Proposed Temporary Warehouse for Storage of Construction Materials for a Period of 3 Years at Lots 1684 (Part), 1685 (Part) & 1686 (Part) in D.D. 129, Lau Fau Shan, Yuen Long, N.T.

We write to confirm that the site area of the application site is about $1,048m^2$. We have updated page 2, 5, 10 & 11 of the S.16-III application form for your further processing of the captioned application.

Proposed Temporary Warehouse for Storage of Construction Materials for a Period of 3 Years at Lots 1684 (Part), 1685 (Part) & 1686 (Part) in D.D. 129, Lau Fau Shan, Yuen Long, N.T.

R to C for Comment from the Geotechnical Engineering Office

SITE LAYOUT PLAN

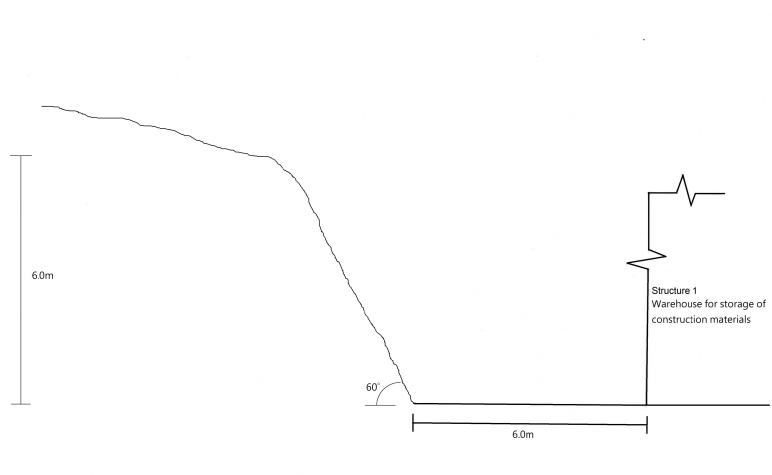
Section 4. According to the proposed site layout plan in Appendix D, the northeastern part of the application site (i.e. the proposed location of the "7m wide Ingress/Egress") would encroach onto Feature No. 2SW-C/C117. The proposed site layout appears to be contradicting to the statement "No excavation lateral support, foundation and site formation works will be carried out". in Section 4 of the GPRR. Please ask the applicant to clarify and revise the GPRR as necessary. Section 5. Please ask the applicant to provide justifications to the statement "the proposed facilities will not be affected by potential landslide debris" with consideration of the travel angle of potential landslide debris in accordance with GEO Technical Guidance Note No. 15.	The revised Section A-A with the shadow angle is enclosed for further comment.
Please remind the applicant of the requirements of making necessary submission(s), including any necessary stability assessments on existing/proposed geotechnical features within or in the vicinity of the application site, to the Buildings Department for approval as required under the provisions of the Buildings Ordinance.	Noted.

Our response to the further comments of the Geotechnical Engineering Office (GEO) is found in the attachment. Structure 1 will be shifted to the north for 1m as shown in the updated layout plan (Figure 3).
